NRL/MR/7441-94-7546

## Digital Mapping, Charting, and Geodesy Analysis Program: Initial Technical Review of Raster Product Format

October 31, 1994

Figure 1. Example diagram showing boundary rectangle, frame, and subframe referencing

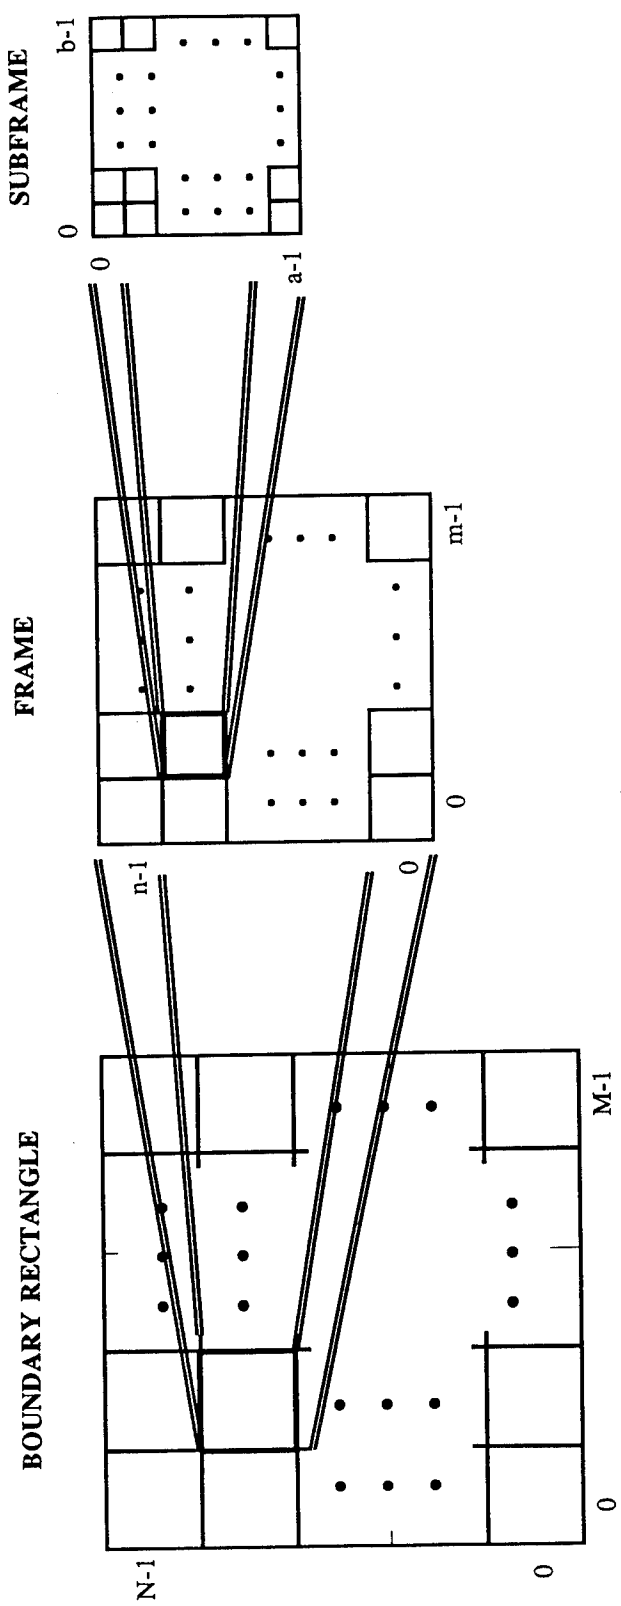
p. 21 Different variables should be used to describe subframe size in sections 5.1.3.c.1 and 5.1.3.c.2 since N and M were used to describe frame size in 5.1.3.b.1 and 5.1.3.b.2. A figure (an example is given in Fig. 1) showing the way in which frames and subframes are referenced within boundary rectangles is recommended.
